Aero service letter No. SL-AG-61

Service Letter No. SL-AG-61
July 13, 1970

AILERON BAY SKINS

EFFECTIVITY: Aircraft Model S-2C, S-2D, & S-2R; Serial Number 1190C & Subs., All S-2D & S-2R.

Drawing – Service Letter #61

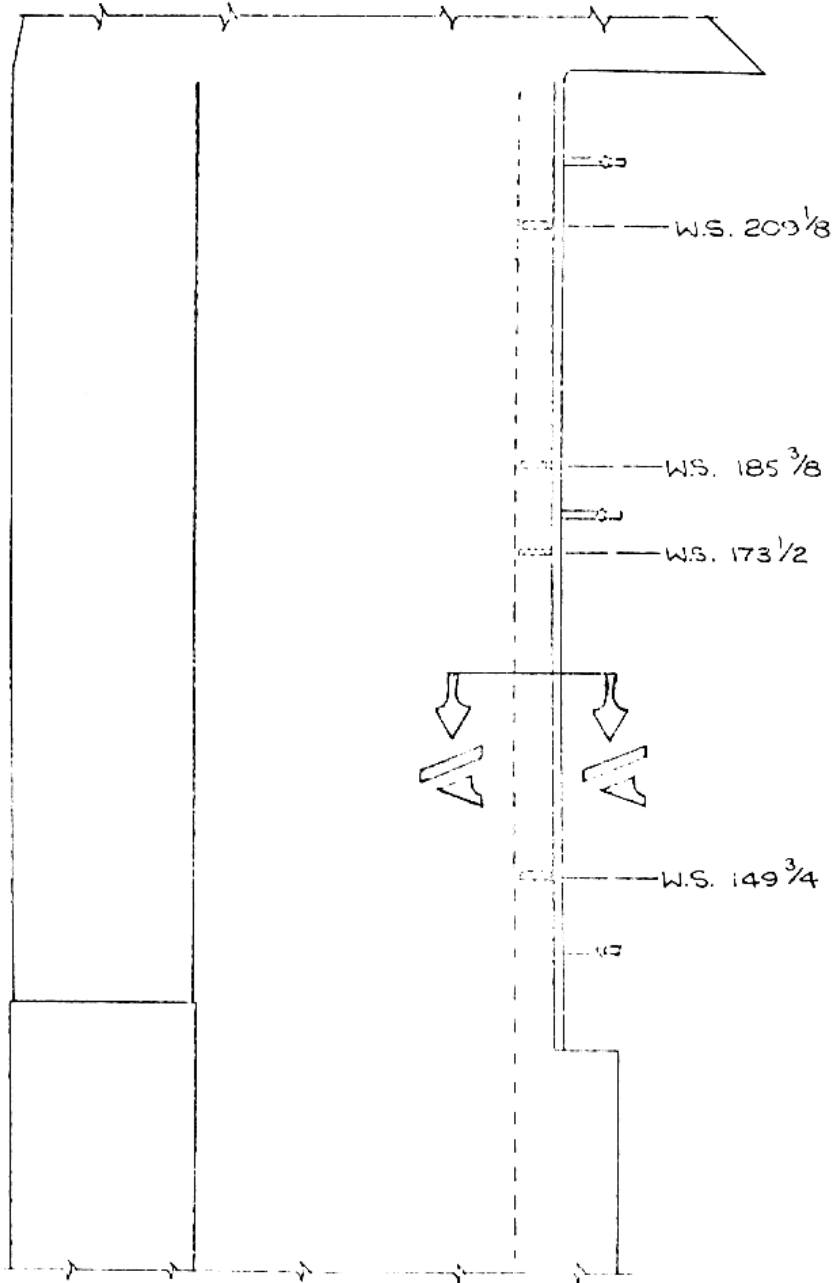
There have been several reports of the upper and lower aileron bay skins cracking out.

New heavier gauge bay skins and new support ribs are available to remedy this situation.

5. Locate the 20360-1 left hand and the 20360-2 right hand ribs in line with main ribs and up on rear spar to assure correct line of upper bay skin. (Use the template mentioned in the previous portion of this letter to locate the ribs vertically.)

8. Drill lower flange of the bay skin to match lower wing skin and spar. Rivet after drilling.
9. Mark rib line on top skin and drill #30 diameter holes, two in each rib, through upper bay skin and rib. Leave 1/4 inch edge distance from each end of rib flange as shown on attached drawing.
